Subject: Duke Energy Carolinas, LLC
Oconee Nuclear Station, Units 1, 2, and 3
Docket Numbers 50-269, 50-270, and 50-287,
Renewed Operating Licenses DPR-38, DPR-47, and DPR-55
Licensing Basis for the Protected Service Water System - Responses to
Request for Additional Information - Supplement 4

Responses to Request for Additional Information
Supplement 4

FIGURE 141-9: ISRS for PSW Building Operating Floor (EL 797'-0") - MHE Horizontal Direction, CLB-LSS Envelop

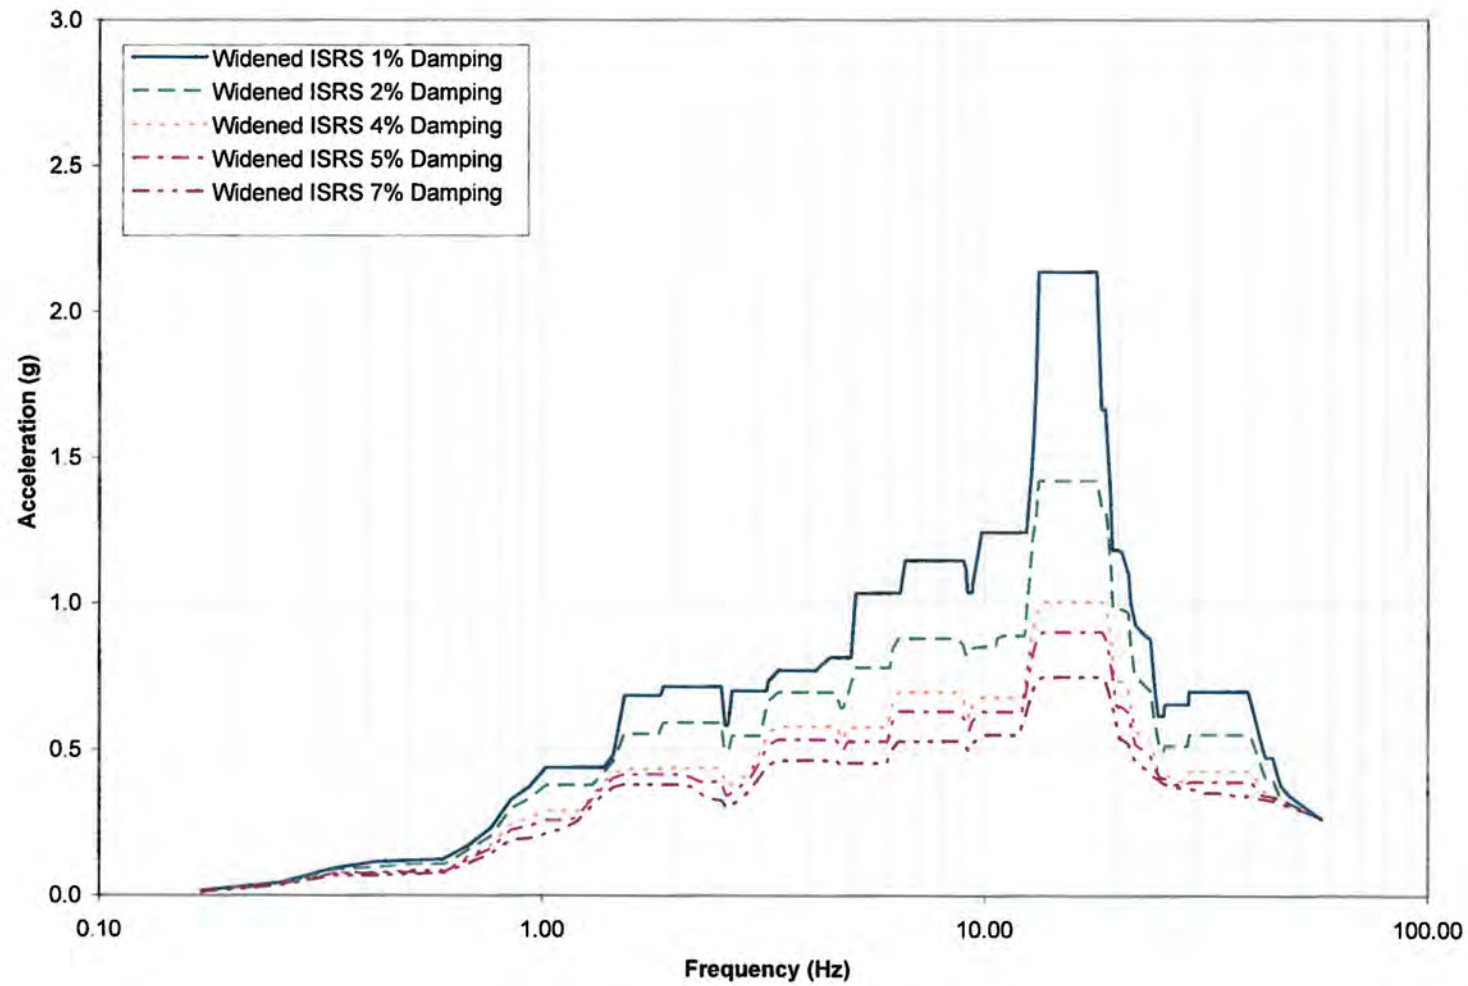
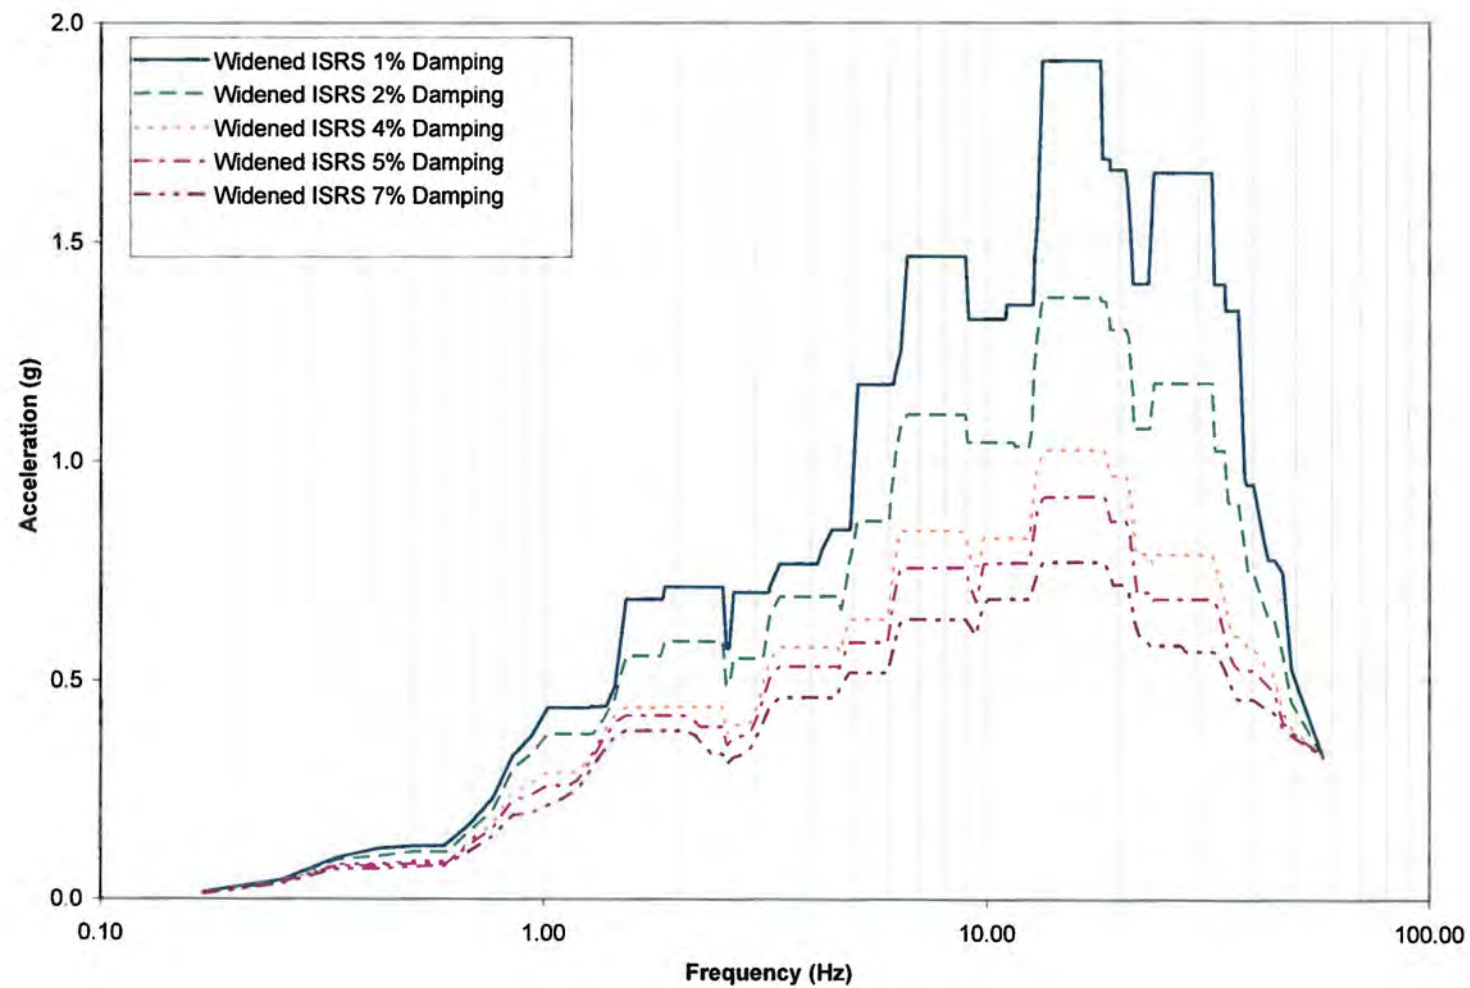
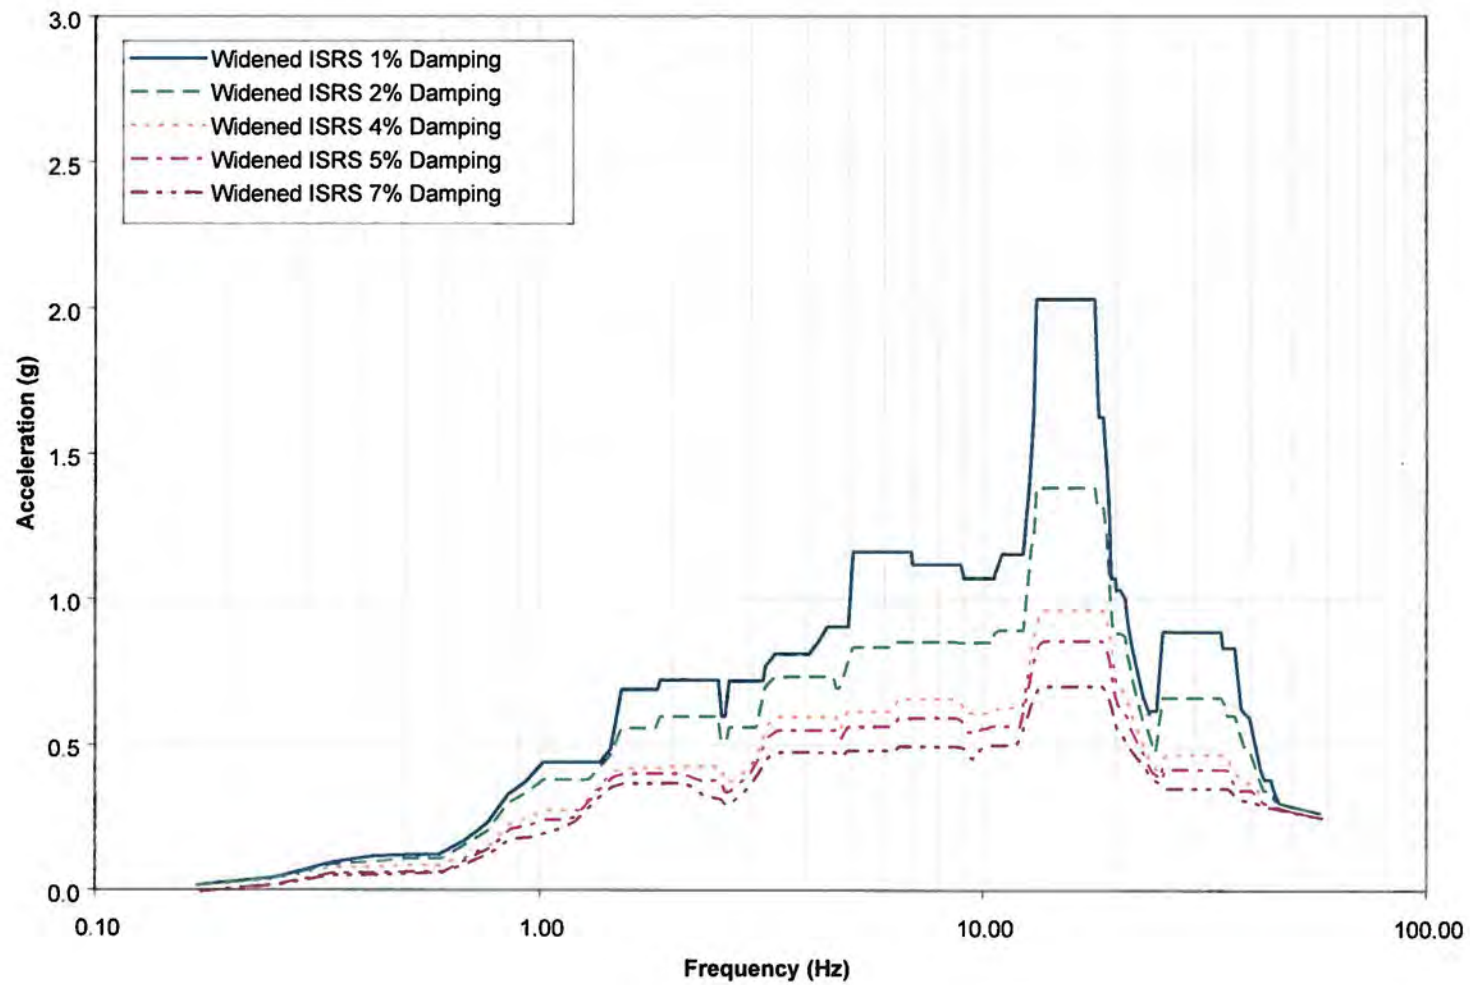
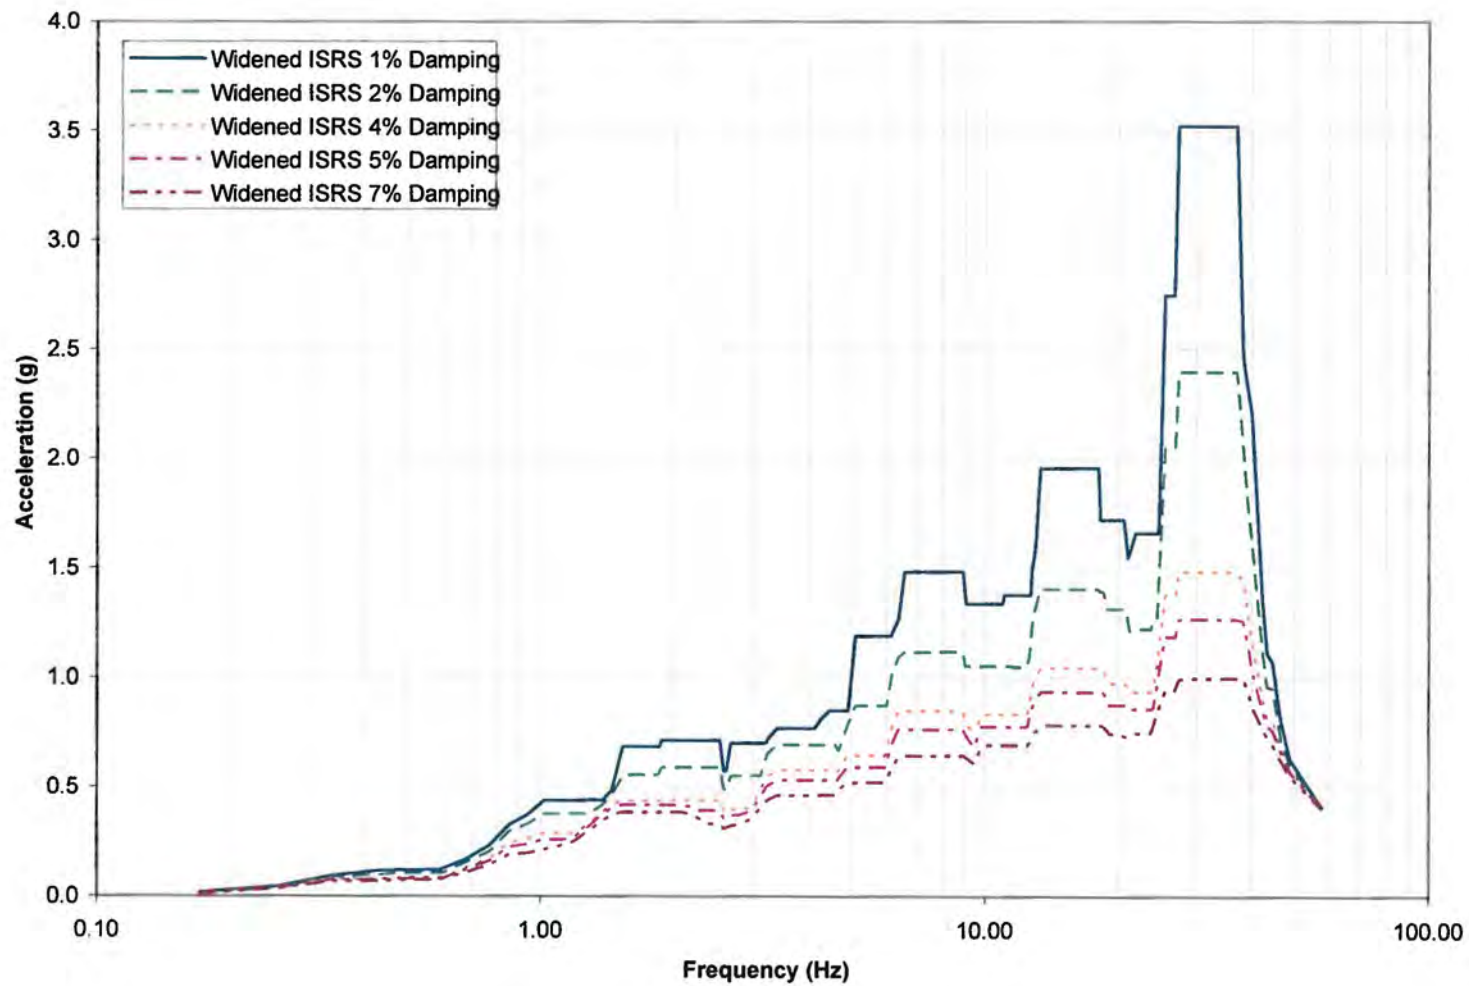
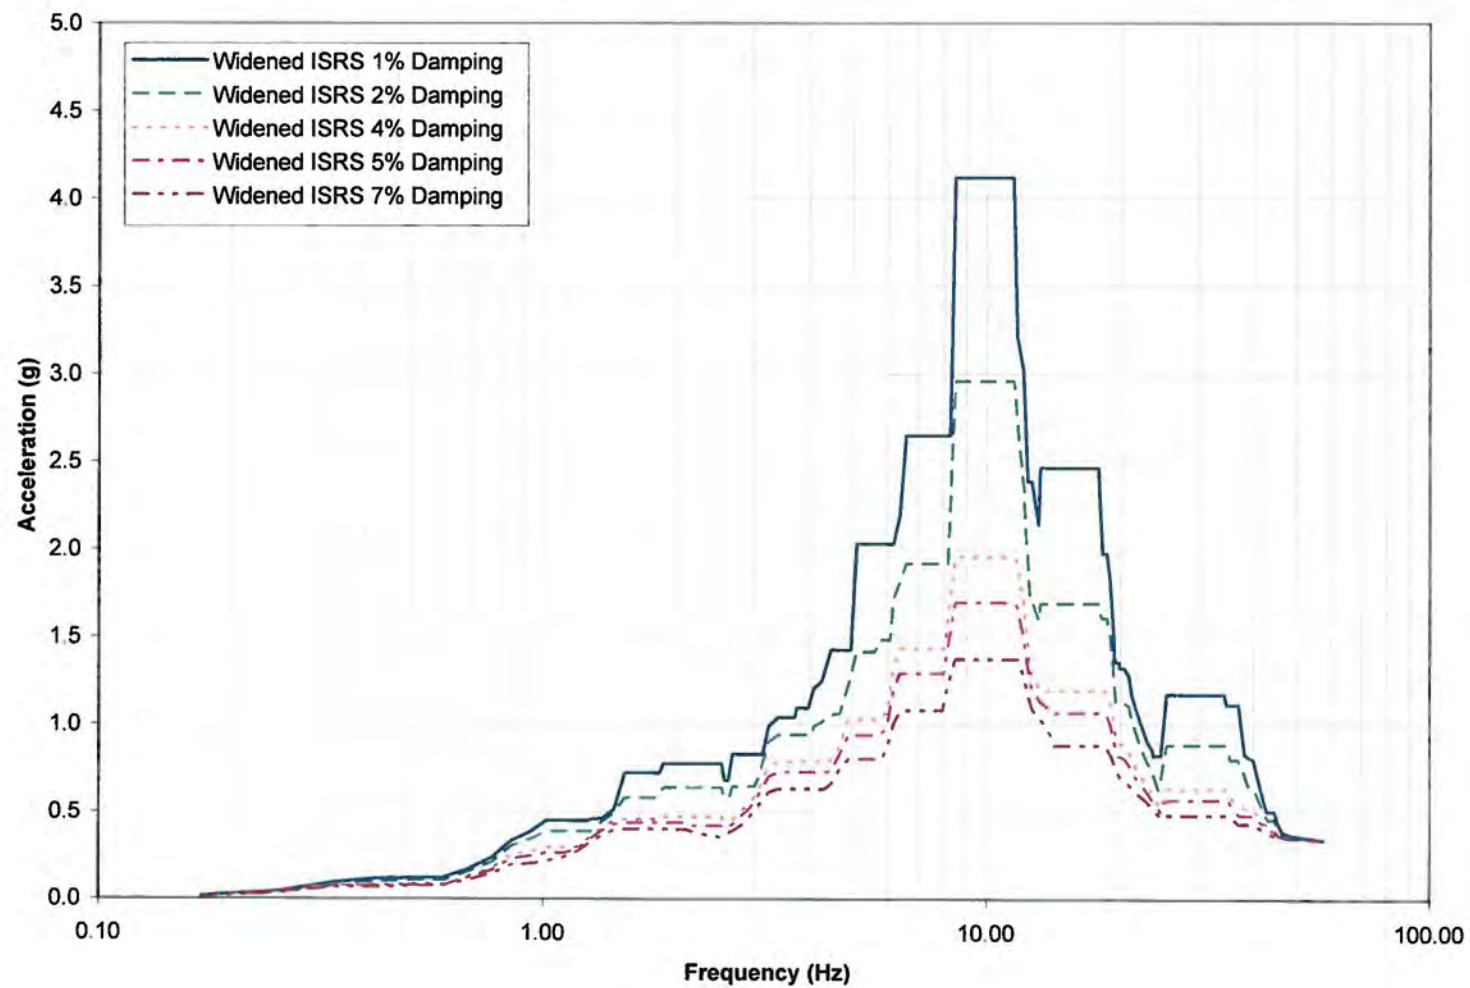
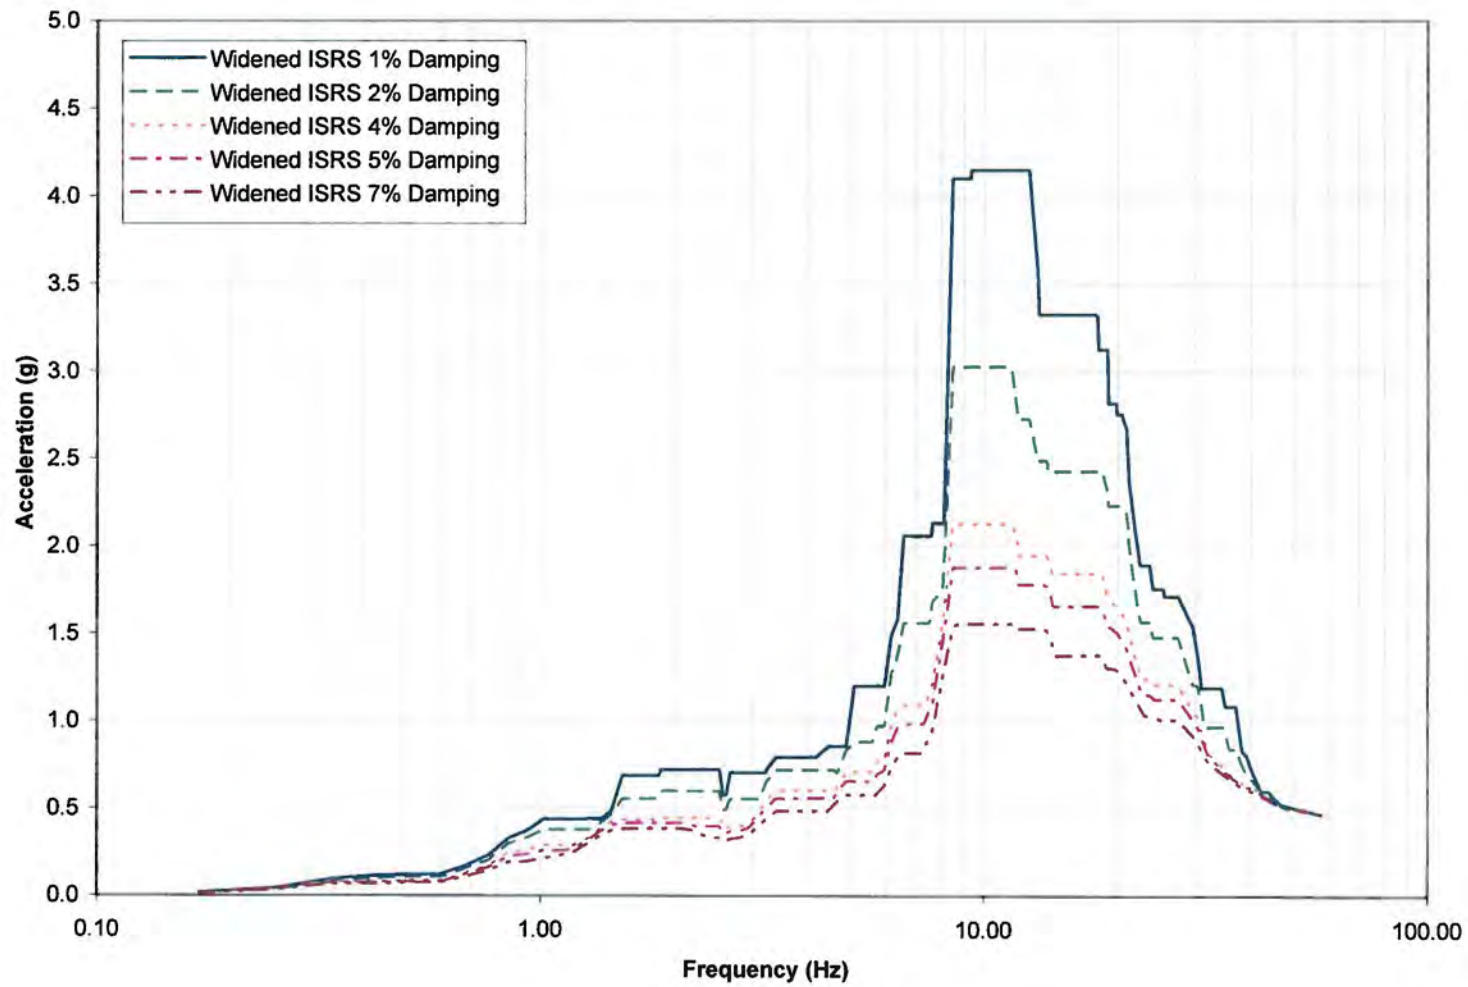
- b) Provide a detailed description of the procedures used for the seismic analysis of the PSW building and to develop the in-structure response spectra (floor design response spectra). If different from the methods and acceptance criteria outlined in the NRC standard review plan (SRP) 3.7.1 and 3.7.2, identify those differences and provide justification that the PSW building is adequately designed, using these alternative methods, to withstand the effects of earthquake loads.

For PSW building ISRS generation, the time history method of analysis was used to develop absolute acceleration time histories at the various nodes where equipment is located. The ground motion input (El Centro N-S 1940 time history normalized to 0.15g) for the time history response analysis is described in paragraph a) above.

Figure 141-17: Shear-Wave Velocity Data at PSW Building Locality

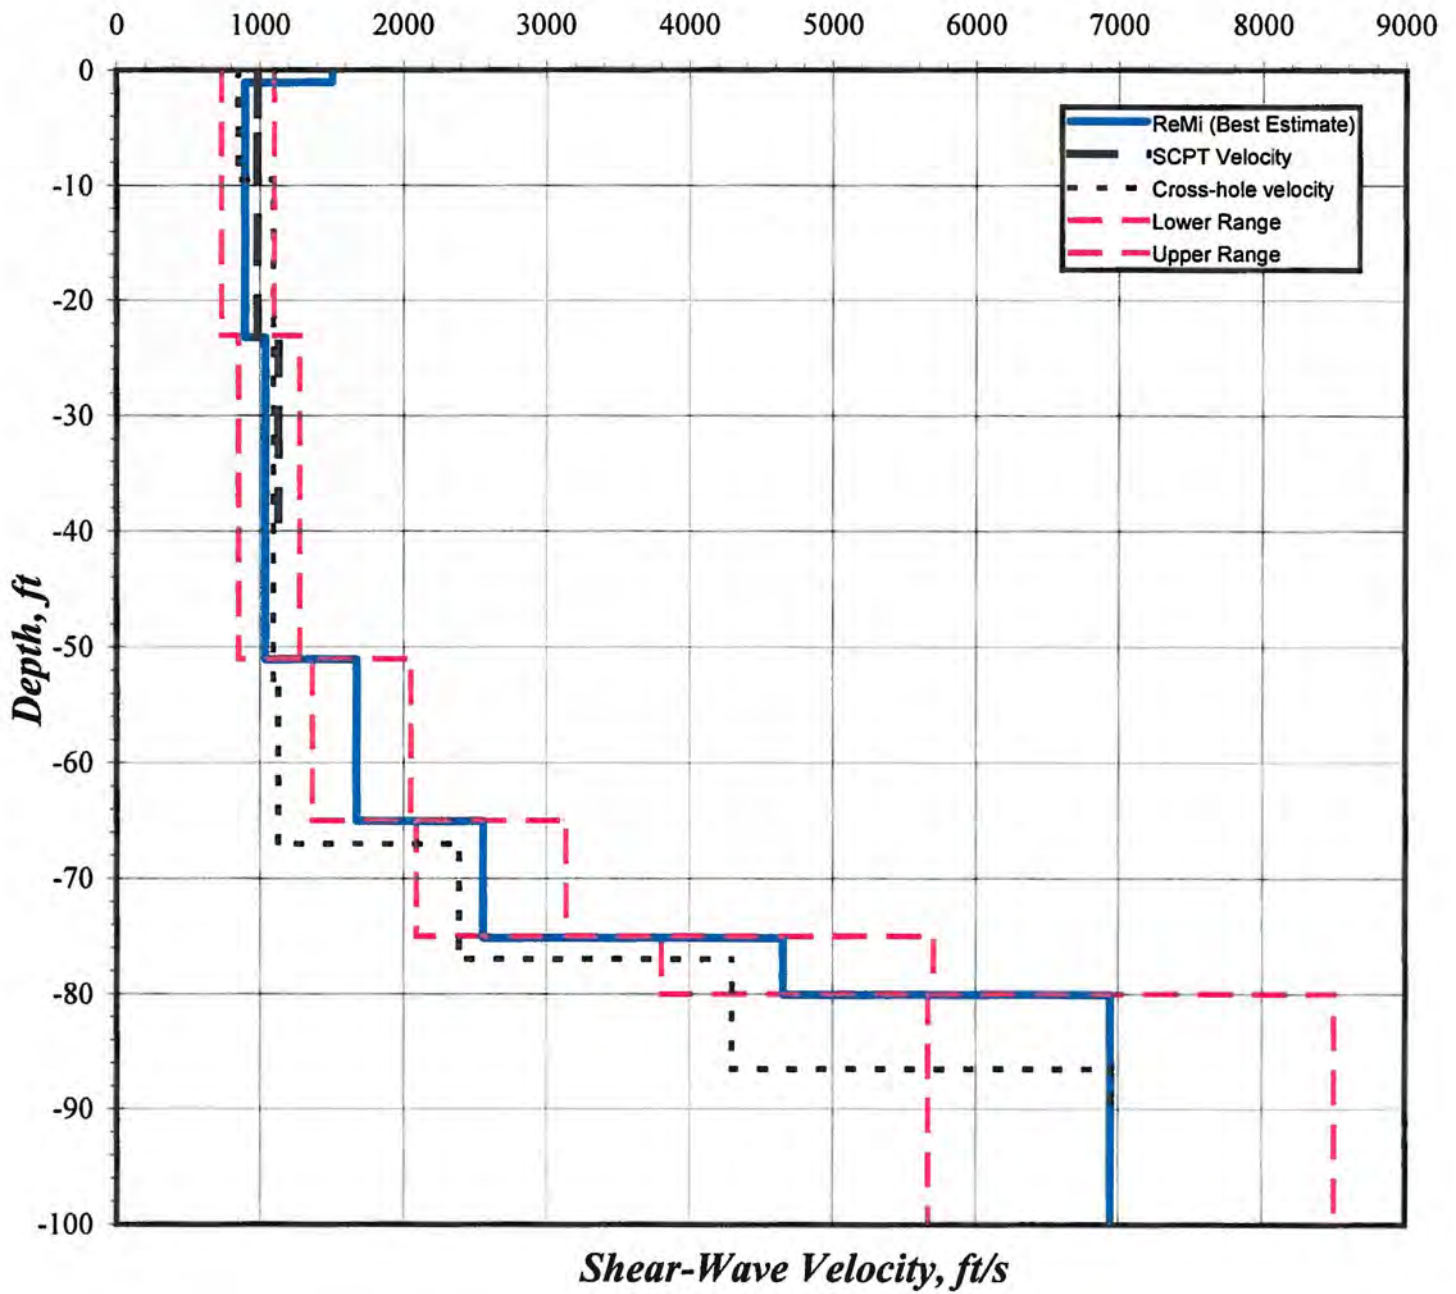
- a) Considering that the PSW building is described as founded on the structural fill, provide a detailed description of rock motion, anchoring point for the input motion, and material properties of soil profile(s) overlaying bedrock (thickness, shear wave velocity, and other relevant material properties. Also, discuss the response amplification calculation process that was used to determine the free-field horizontal and vertical ground motion at the PSW building.

over the length of the survey line and the ReMi survey line encompassed the length of the PSW building. The BE shear modulus values were calculated from the corresponding BE shear wave velocities. The LB and the UB shear modulus values obtained using an assigned coefficient of variation (COV) of 0.5 were used to calculate the low strain LB and UB shear wave velocities, respectively. Figure 141-17 presents the values of shear wave velocities versus depth for the PSW building site. As shown in Figure 141-17, the shear wave velocities values obtained from independent geophysical tests are consistent, and the LB and UB values of shear wave velocities reasonably bracket the values of shear wave velocities calculated from the various measurements (ReMi, SCPT, and CHV). For this reason, the use of a COV value of 0.5 for shear modulus is justified.
